Grandview Reserve Phase 2 Preliminary Drainage Report

July 2024

PUDSP236

SHEET DRN 1

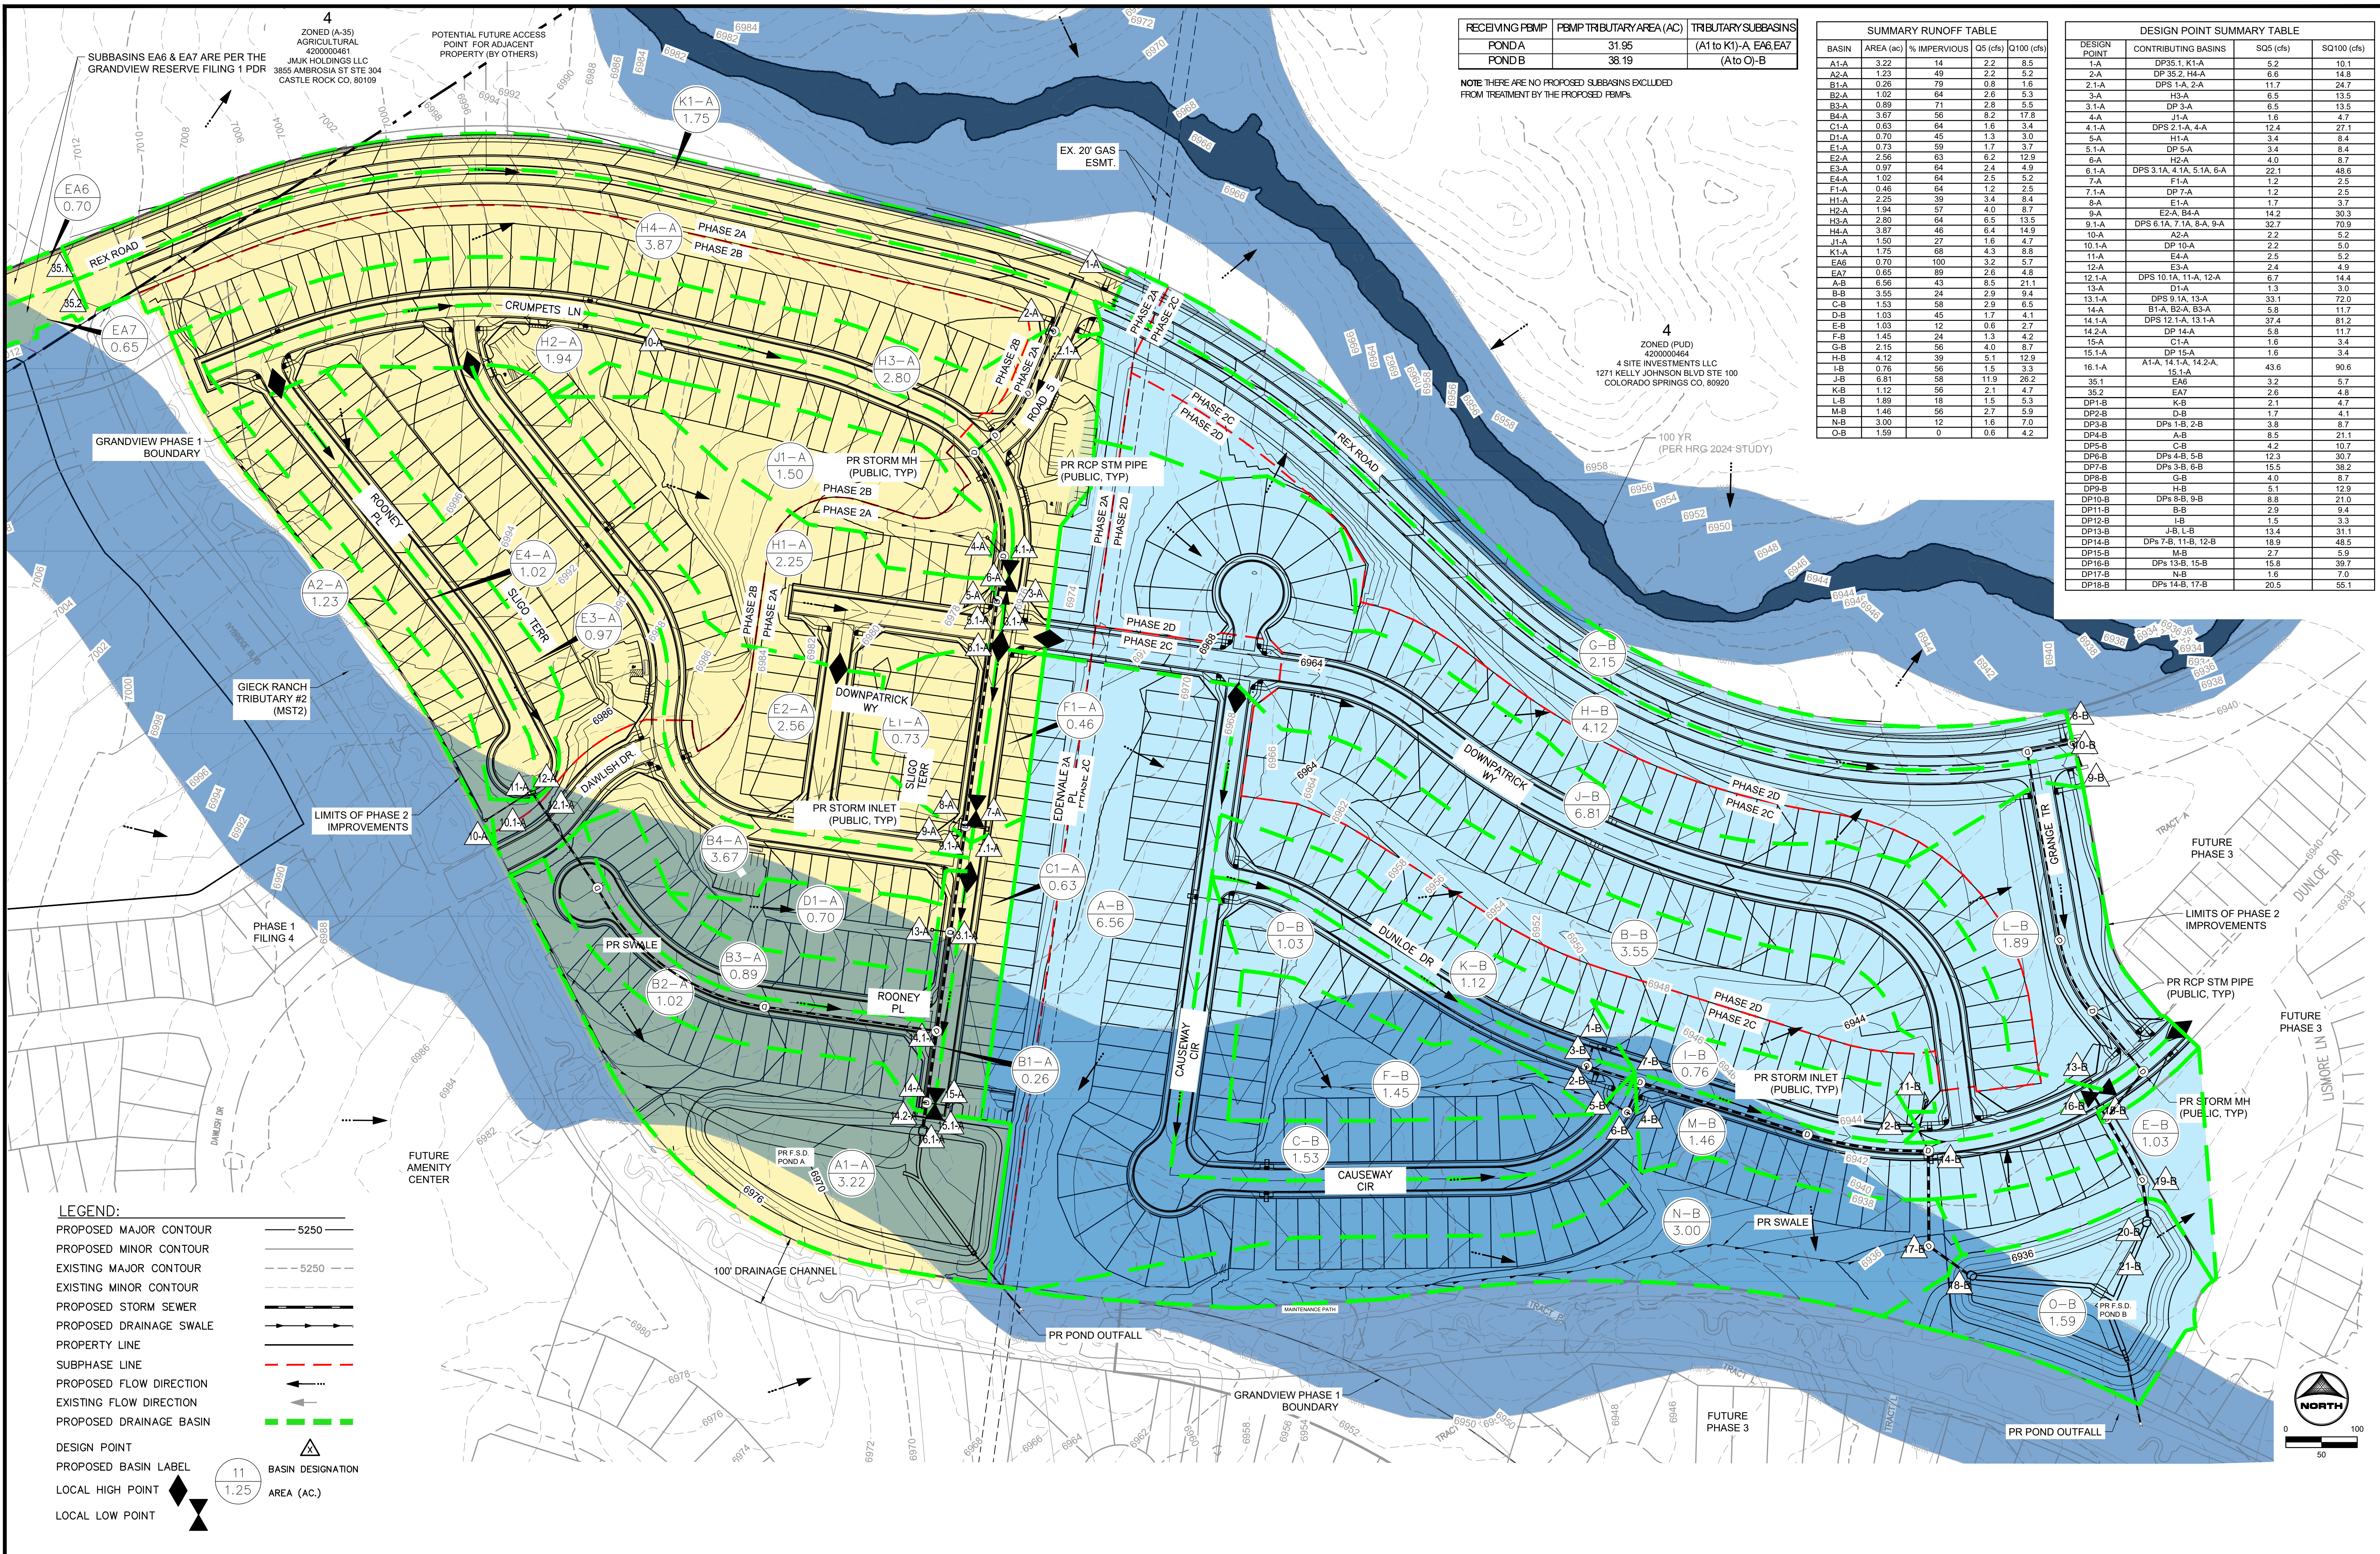
Response acknowledged, however, please provide an existing drainage map, specifically for Phase 2. Include design points that will correspond to pond release locations, so historic flows can be compared to pond release rates.

EXISTING DRAINAGE MAP WITH DESIGN POINTS CORRESPONDING TO POND RELEASE LOCATIONS ADDED

NARRATIVE ADDED
